Town of Medway
DESIGN REVIEW COMMITTEE
155 Village Street, Medway MA 02053
(508) 533-3291

DRC Meeting Minutes: June 04, 2018 Medway Public Library

Design Review for 9 Trotter Drive site plan for Converting Technical Services

Project	Sheet
ELEVATION	S-2
Date	4/16/18
Scale	3/16" = 1'-0"

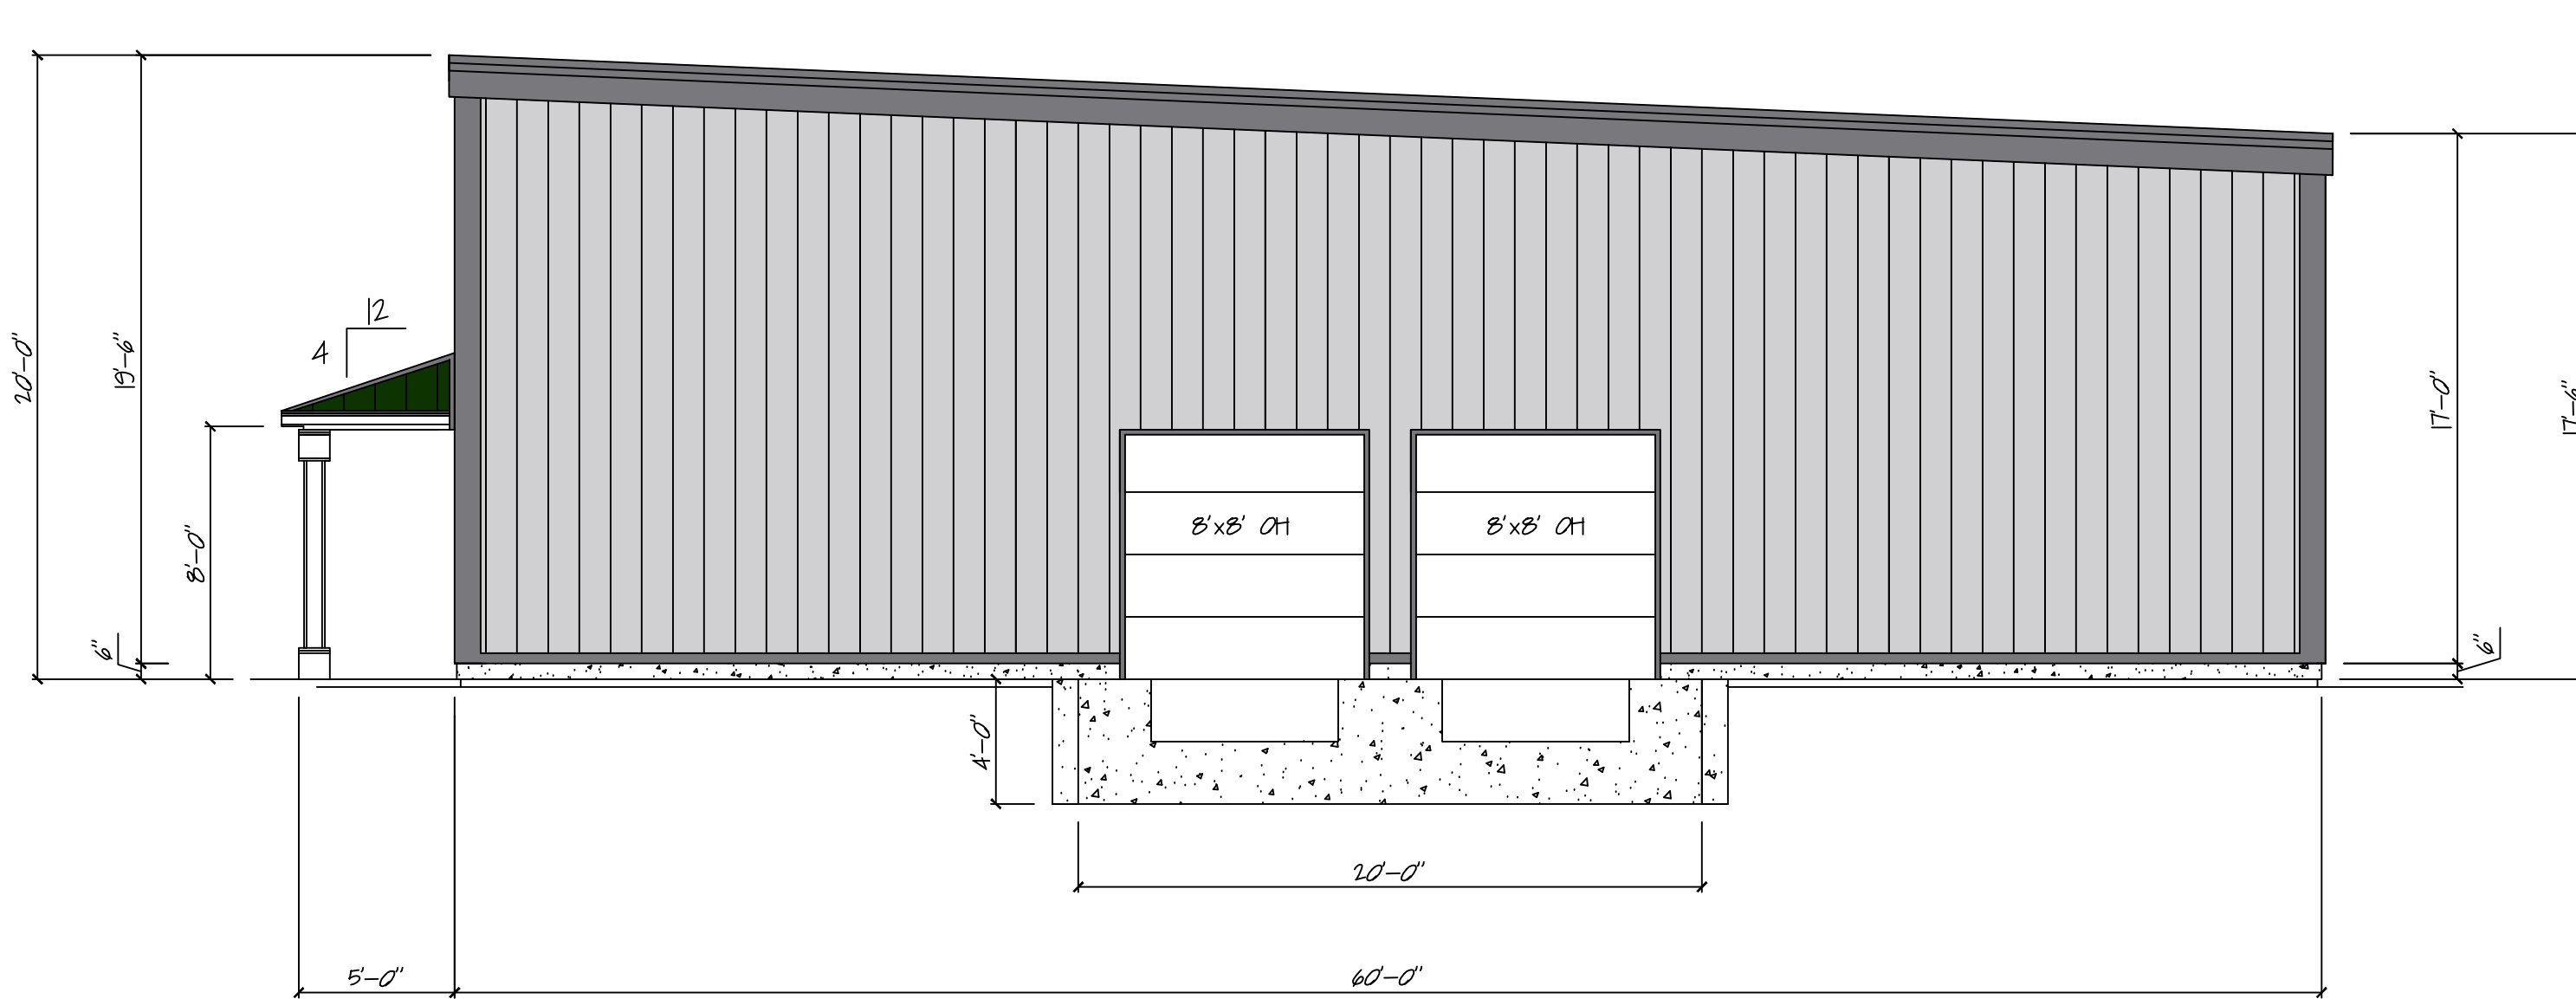
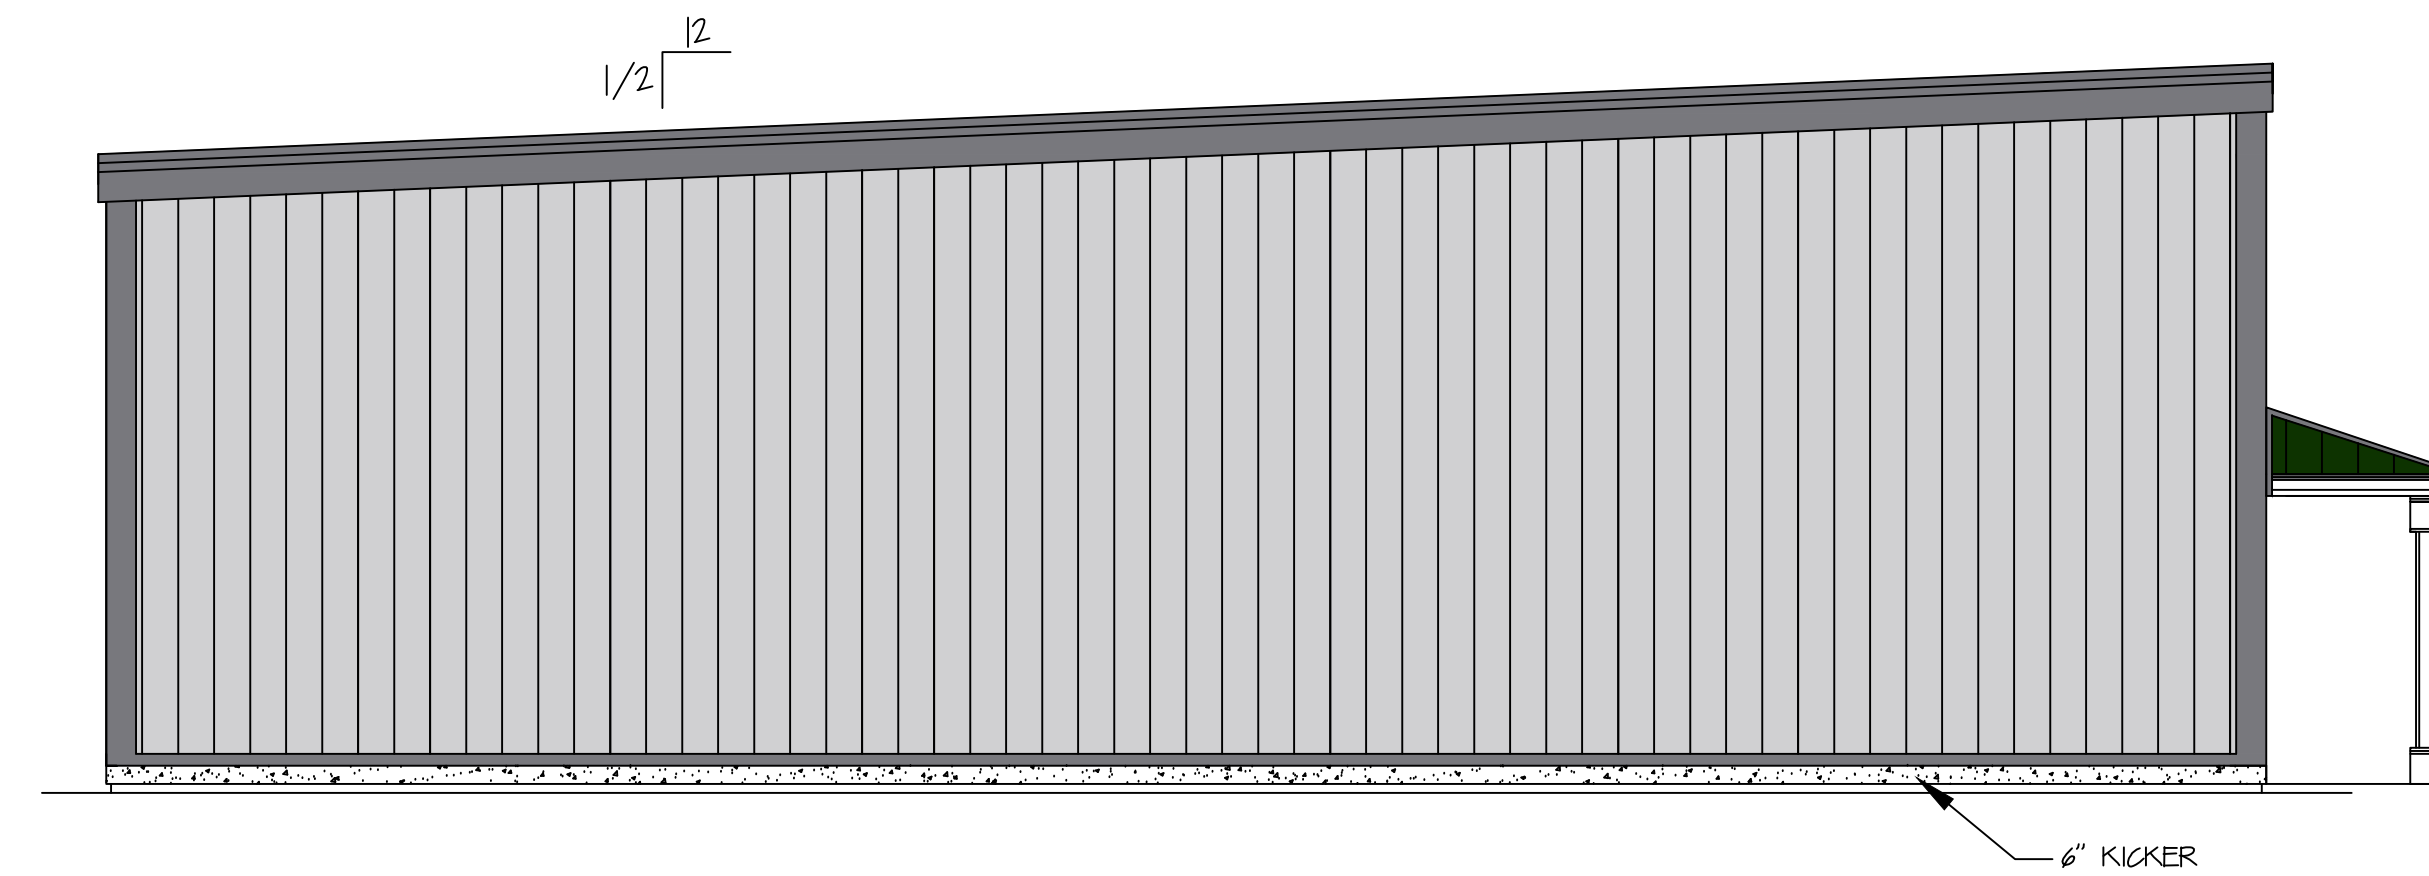
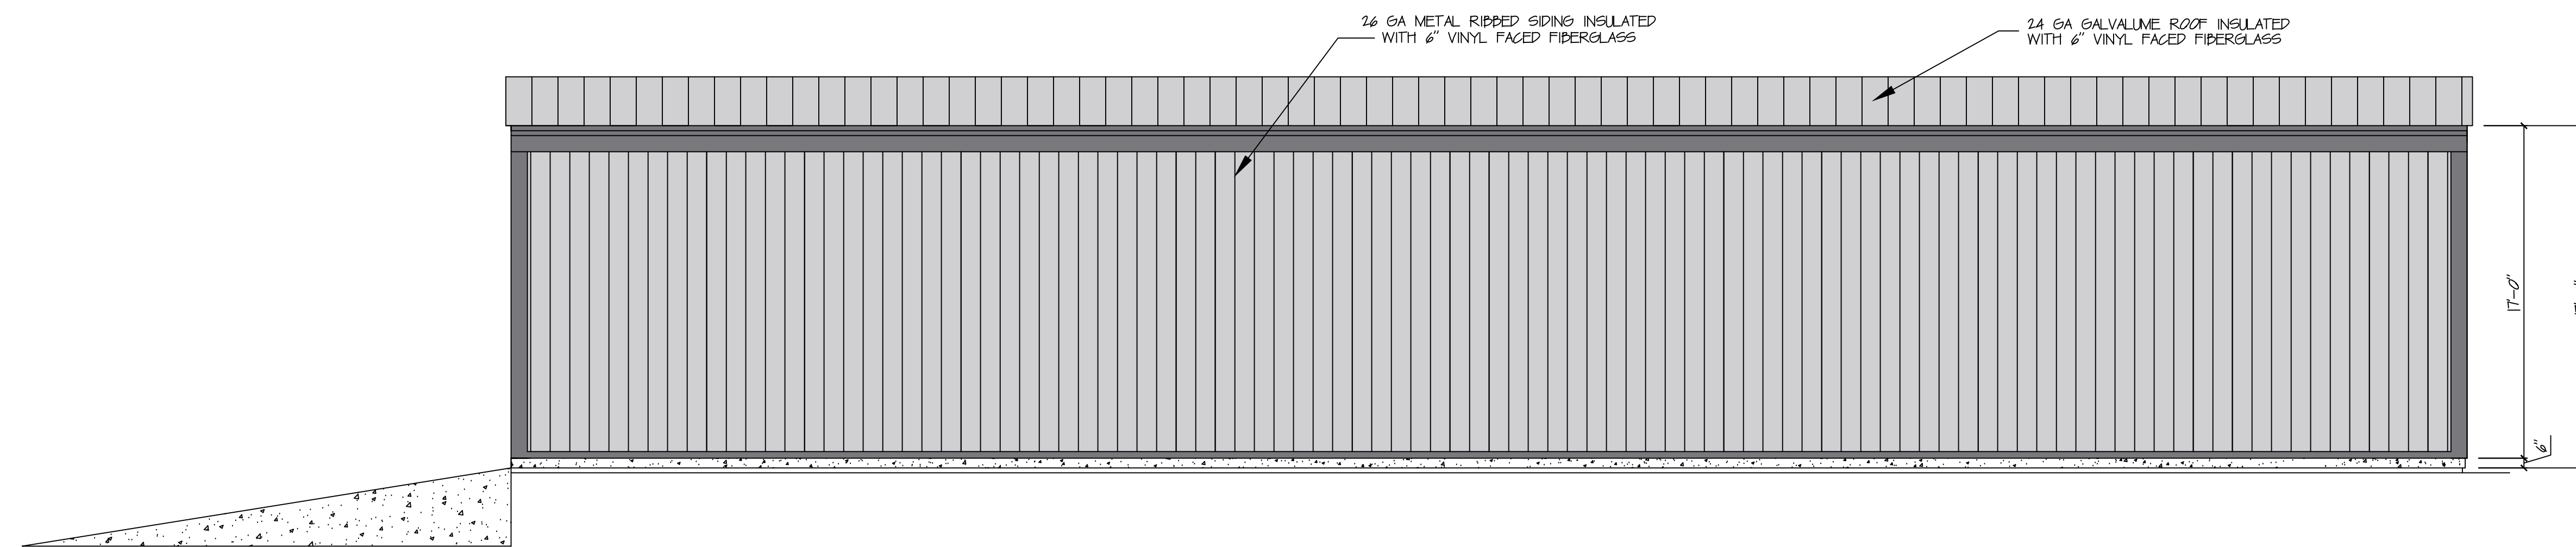
- ❖ Standard industrial LED light fixtures are proposed on the building and in the parking lots.
- ❖ Mr. Buckley asked that some more detail and effort should be put into the aesthetics of the building. Mr. Bemis explained that budget and other limitations might prohibit the applicant from making extensive design changes.

- ❖ The color of the siding and the type of masonry was discussed. Ms. Chabot asked if there was any opportunity to change the dimensions of the proposed doors/windows in the building. Mr. Bemis explained that these changes are constrained by the budget. If it helps budget wise, members recommended eliminating the masonry from the design. Discussion ensued on potential colors that could be considered for the final design. Landscaping around the building was also discussed.
- ❖ Mr. Bemis agreed to come back before the Committee on June 18th with some alternatives with some colors based on the discussion tonight.
